## Groundwater Review Summary Form

Application # G- 18352

GW Reviewer DENNIS ORLOWSKI Date Review Completed: 4/19/2017

**A. GENERAL INFORMATION:** Applicant's Name: All Wood Restoration (Munro) County: Clackamas

Water-Level Trends in Nearby Wells

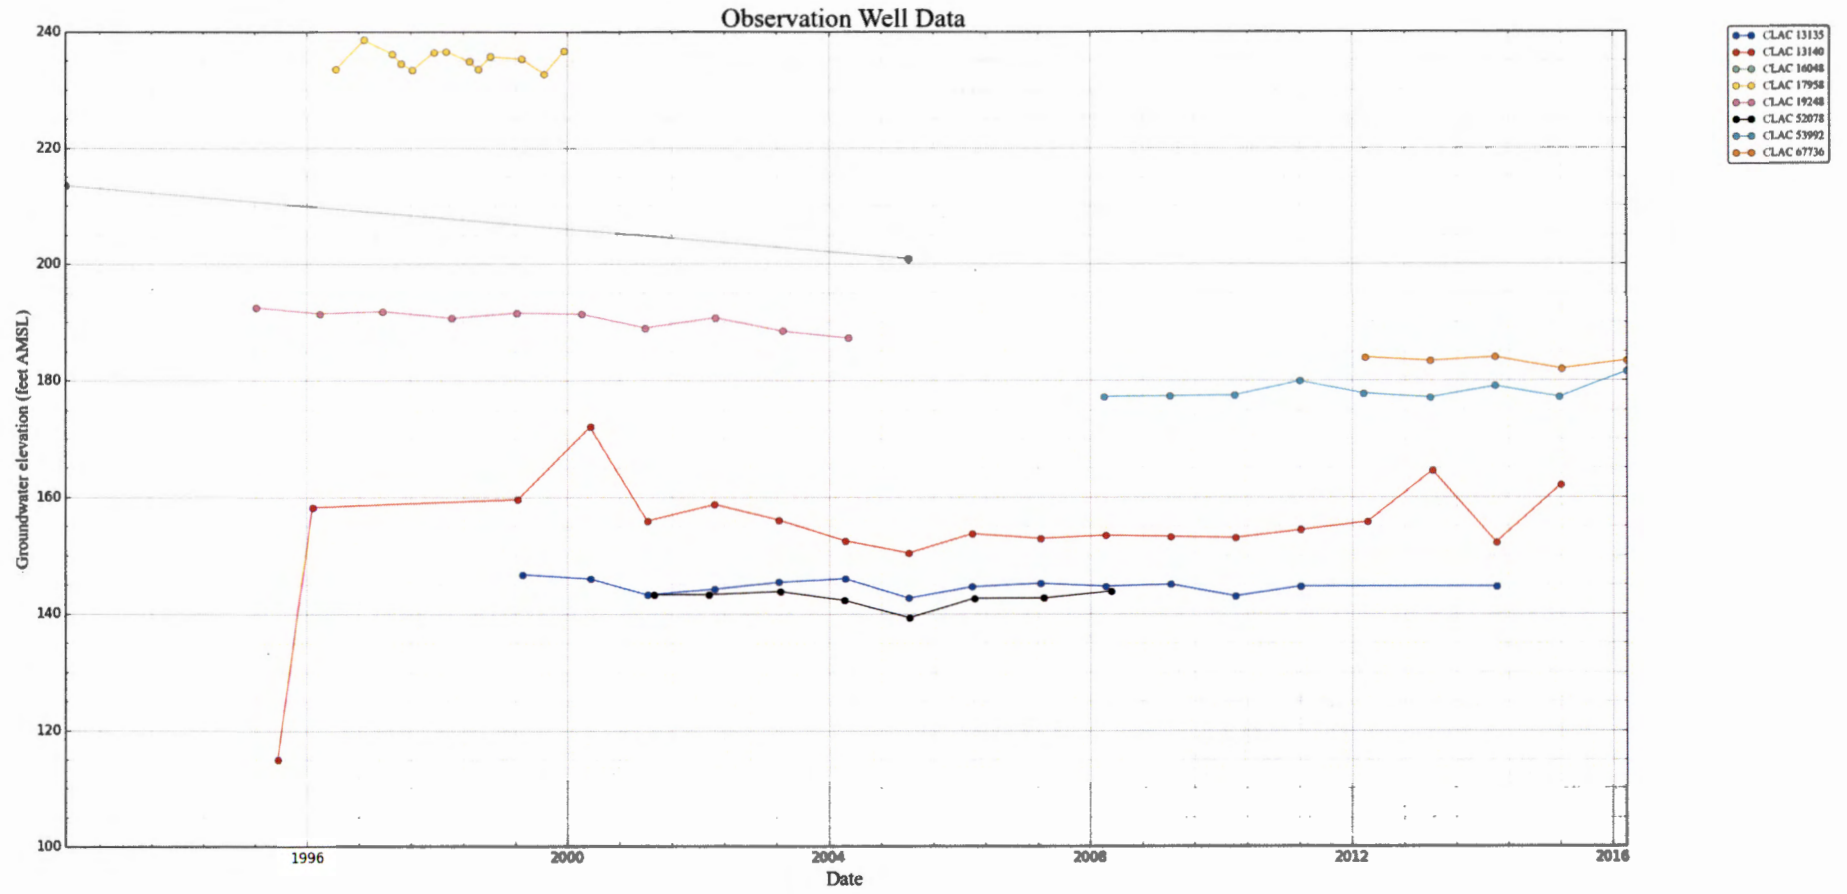
Available data from nearby wells completed in the alluvium indicate that groundwater levels have been relatively stable for at least the past 20 years (see attached hydrograph). Generally stable groundwater levels, localized high recharge rates, and currently low well density suggest that groundwater will be available at the requested allocation.

Stream Depletion Model Output

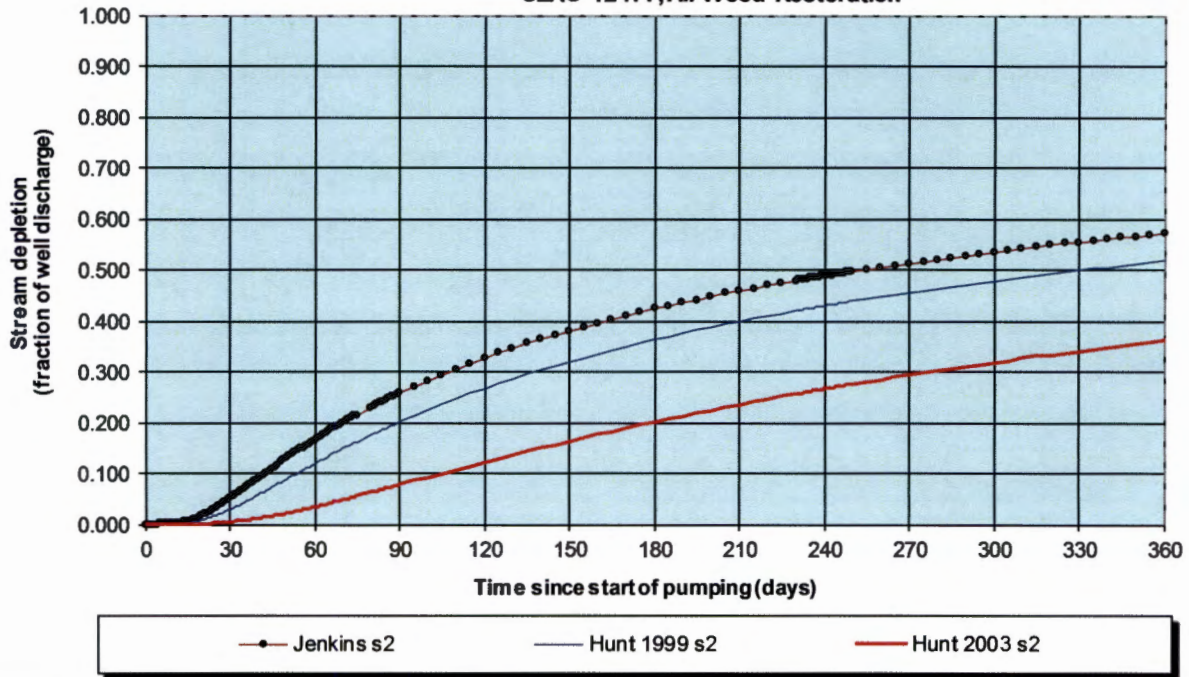
Interference between proposed POA/Well 1 and the Molalla River was estimated using the Hunt 1999 stream depletion model (Hunt, 1999). Aquifer thickness (50 ft) was calculated assuming a static groundwater level of 10 ft bls and the bottom of the water-bearing sand unit at Well 1 at approximately 60 ft bls. Aquifer hydraulic conductivity values ranged from 50 to 250 to 1000 ft/day, corresponding to 'silty sand' to 'sand with gravel' as reported in the literature (Freeze and Cherry, 1979) (available pumping test data from nearby wells is sparse and generally not applicable because most of the wells tap deeper formations of different composition). Pumping was set at the maximum requested rate for year-round use as a worse-case scenario.
